PROJECT REVIEW REPORT

Project ID	1052
Project Name	North Pikounda REDD+
Review Type	Verification
Program(s)	VCS
Verification Period	01-January-2013 to 31-October-2021
Project Proponent	Congolaise Industrielle des Bois
Methodology	VM0011 Methodology for Calculating GHG Benefits from Preventing Planned Degradation, Version 1.0
VVB	KBS Certification Services Ltd
Assessment Criteria	VCS Standard, version 4.5
Date of First Issue	04 July 2024
Date of Second Issue	19 September 2024
Date of Third Issue	26 September 2024
Review Conclusion	Approved
Date of Final Issue	17 January 2025

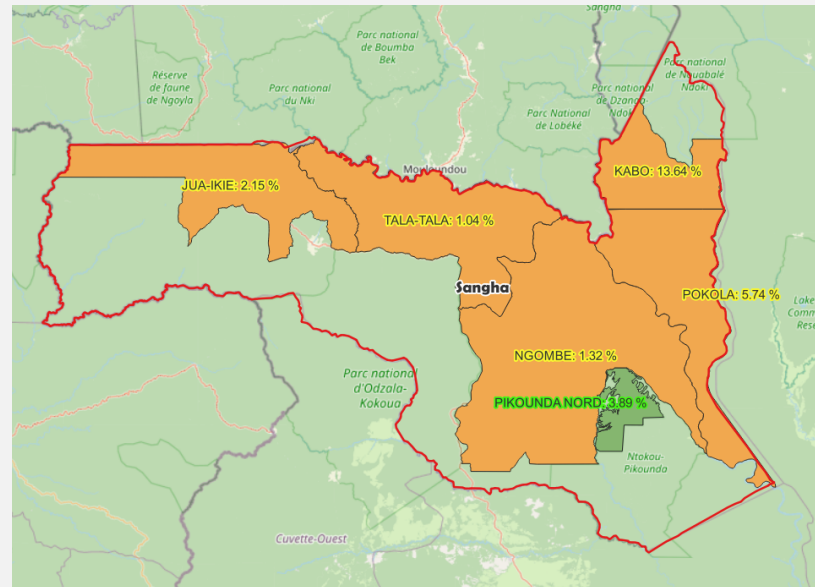
6 Missing information on leakage emissions and leakage assessment		
<p><u>Issue</u> Section 5.3 of the MR refers to Appendix 3a for a broader explanation and Appendix 3c for the calculations of leakage emissions, however, these have not been provided.</p>	<p>Round 1</p> <p><u>VVB Response</u> PP has provided an update to section 5.3 of MR, to include the relevant leakage equations and justification for the methodological choices.</p> <p>Section 4.3 of VR is updated to reflect changes.</p>	<p>Closed</p>
<p><u>Action Required</u></p> <ol style="list-style-type: none"> 1) The VVB must ensure the project proponent provides Appendix 3a and Appendix 3c for review. Additionally, the MR must be updated to include the relevant leakage equations and justification for the methodological choices. 2) The VVB must describe how it validated, against objective evidence, the data and parameters applied by the project in justifying the leakage emissions ($C_{leakage}$) are equal to 10% of the baseline for this 	<p><u>Verra Response</u> Section 5.3 of the MR has been updated to provide the calculations of leakage emissions. However, this finding cannot be closed.</p> <p><u>Issue</u> Verra cannot efficiently review the leakage emissions calculations without Appendix 3a, Appendix 3c, and the full citation of the paper by Sharma et al. (2012) referenced by the PP.</p> <p><u>Action required</u> The VVB must provide Verra with Appendix 3a, Appendix 3c, and the full citation of the paper by Sharma et al. (2012) to facilitate efficient review of the leakage calculations.</p>

<p>whether it meets the requirements in section 3.20.2 of the VCS Standard v4.5. The VR must be updated accordingly.</p> <p><u>Background</u> <i>VM0011, v1.0, Section 5.3:</i> The Project Proponent must demonstrate how market leakage has been accounted for in accordance with the most recent version of applicable VCS rules.</p> <p>The VCS Methodology Requirements are intended for methodology developers, while the VCS Standard is designed for project developers. Accordingly, the project should refer to the VCS Standard v4.5, specifically Table 3.</p>	
		<p>Round 3</p>	
		<p><u>VVB Response</u> The verification team has reviewed the leakage calculations for the project, now the project has quantified market leakage according to the methodology provisions, specifically Table.3 of the VCS Standard v4.5.</p> <p>Further verification team reviewed the calculations to ensure the accuracy and reliability of the data and parameters used by the PP to justify that leakage emissions ($C_{leakage}$) equal to 20% of the baseline for this monitoring period.</p> <p><u>In the MR, the following is included</u> Now PP has reassessed the leakage of the project in line with Table.3 of the VCS Standard v4.5. For that, the ratio of merchantable to total biomass was calculated in other concessions close to the concession of the project in the Shanga region. The explanations are</p>

As depicted in the map and the table below the ratio of merchantable to total biomass is summarized. The aggregated value of all the regions where leakage could be displaced in the Shanga region (Pokola, Kabo, Ngombe, Tala-Tala, and Jua-Ikie concessions) is 4.78% compared to the 3.89% from the Pikounda concession.

Concession	Ratio of merchantable biomass to total biomass (R _{merch-total biomass})	Aggregated ratio	
	% (AGB m3/ha)	% (AGB m3/ha)	
PIKOUNDA	3.89%	3.89%	Pikounda
POKOLA	5.74%	4.78%	Concessions in Shanga Region
KABO	13.65%		
NGOMBE	1.32%		
TALA-TALA	1.04%		
JUA-IKIE	2.15%

<p>Therefore, and according to Table.3 of the standard, the ratio of merchantable biomass to total biomass is higher within the area to which harvesting is displaced (4.78%) compared to the project area (3.89%), concluding that the market leakage discount factor applied is 20%.</p> <p>The updated documents (i.e., MR, Appendix 3a, Appendix 3e, Appendix 4 and FVR) are submitted for review.</p> <p>Now as the project has quantified market leakage according to the methodology provisions, specifically Table 3 of the VCS Standard v4.5. This is now reported as a PD Deviation in line with section 3.21 of the VCS Standard v4.7 and an assessment of the same provided in section 3.2 of validation report.</p> <p><u>Verra Response</u> The project documentation has been updated accordingly.</p>	
--	--	--	--

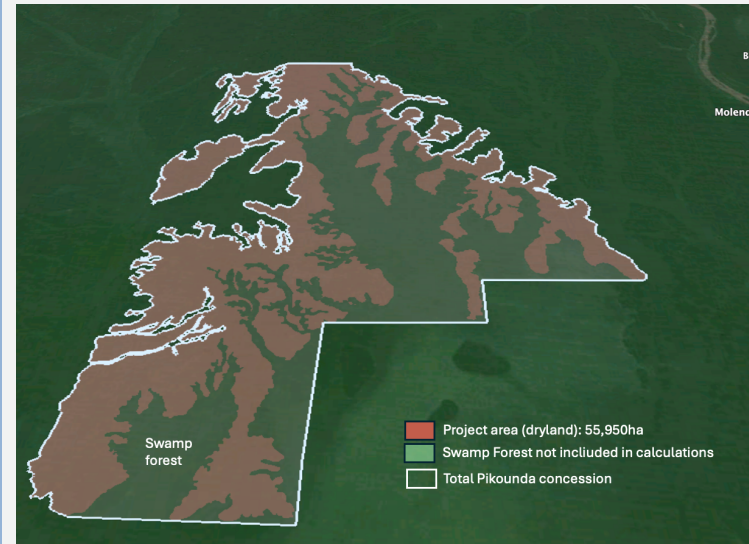
10	The KML includes ineligible area		
	<p><u>Issue</u> It is unclear whether the swamp forest has been excluded from the project area.</p> <p><u>Action Required</u> 1. The VVB must ensure that the swamp forest</p>	<p>Round 1</p> <p><u>VVB Response</u> 1. The KML found in the VERRA webpage of the project represents the entire North Pikounda UFE, the forest concession of CIB/OLAM. As mentioned in the validated PDD, the area includes the following strata:</p>	Closed

The project area polygon in the KML comprise ineligible area i.e., swamp forest.

Per VM0011, v1.0, the methodology is applicable in tropical forests, including evergreen tropical rainforests, moist deciduous forests, tropical dry forests, and tropical upland forests, except peat swamp forests.

Please refer to the table below, which is extracted from the Monitoring Estimation of Credits Pikounda Excel file, for detailed information. The Monitoring estimations file takes into account just the 55,950ha of the dryland forest and not the swamp forest.

In the PDD from 2013 (page 10) the introduction describes the dryland forests accounting for carbon with the same 55,950ha, and a total concession of 92,530ha.

<p>deviation should be done in the current monitoring period.</p> <p>3. There was no change in the accounting area during the Monitoring period, so no project description deviation should be done in the current monitoring period.</p> <p>This Finding is related to the Finding #7. The PP provided an updated version of the project area .kml file, which identified only the forest area. A .kml file of North Pikounda UFE and wetland areas inside the concession is also provided to the VVB and the Standard for consultation.</p> <p>Review and Confirmation by VVB: KML File Review: Verified that the KML files on the VERRA webpage accurately represent the North Pikounda UFE, including both swamp forests and dryland mixed forests. Documentation Verification: Confirmed that swamp forests are excluded from the crediting area and that the ER calculations only consider the dryland mixed forests. Update to Verification Report:</p> <p>Section 3.1 Update: Revised Section 3.1 of the Verification Report (VR) to detail the confirmation of swamp forest exclusion and the accurate</p>

<p>representation of the project area in the KML files. Section 3.2.2 Update: Updated Section 3.2.2 of the MR to reflect that there has been no change in the accounting area and therefore no project description deviation is necessary.</p>	
		<p><u>Verra Response</u> An explanation has been provided regarding the exclusion of the swamp forest from the project area.</p> <p>However, this finding cannot be closed.</p> <p><u>Issue</u> The updated KML file, excluding the swamp forest from the project area, has not been provided to Verra for review.</p> <p><u>Action required</u> The VVB must provide an updated KML file that excludes the ineligible swamp forest to Verra to enable an efficient review of the project area.</p>	
		<p>Round 2</p>	
		<p><u>PP answer</u> The KML from the project was shared with the VVB</p> <p><u>VVB Response</u> The KML file is reviewed and is shared with along with PRR R2.</p>

The updated KML has been provided. This finding is closed and, no further action is required.	
--	--	---	--
